FORD:

2015-2017 Mustang

ISSUE

Some 2015-2017 Mustang vehicles equipped with a manual transmission and built on or before 6/15/2016 may exhibit a no crank condition due to the clutch pedal position (CPP) switch being damaged.

Figure 1 - Article 16-0103

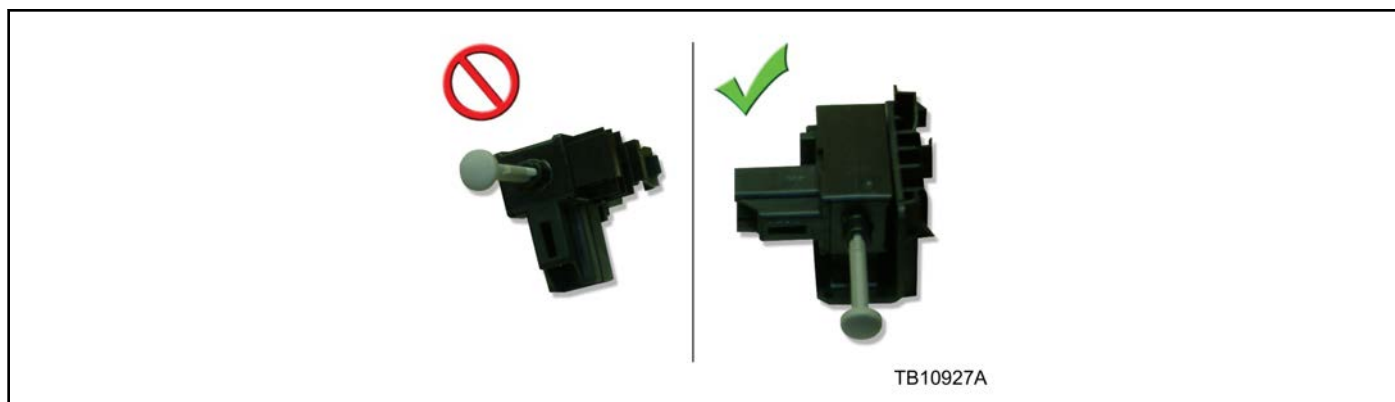
1. Inspect the CPP switch for physical damage. Is the CPP switch damaged?
 - a. Yes - proceed to Step 2.
 - b. No - this article does not apply.
2. Install a new CPP switch and bracket. Refer to Workshop Manual (WSM), Section 303-14. The switch includes a plastic bracket rotating the connector 90 degrees. (Figure 1)

PART NUMBER	PART NAME
HR3Z-11A152-A	Clutch Pedal Switch
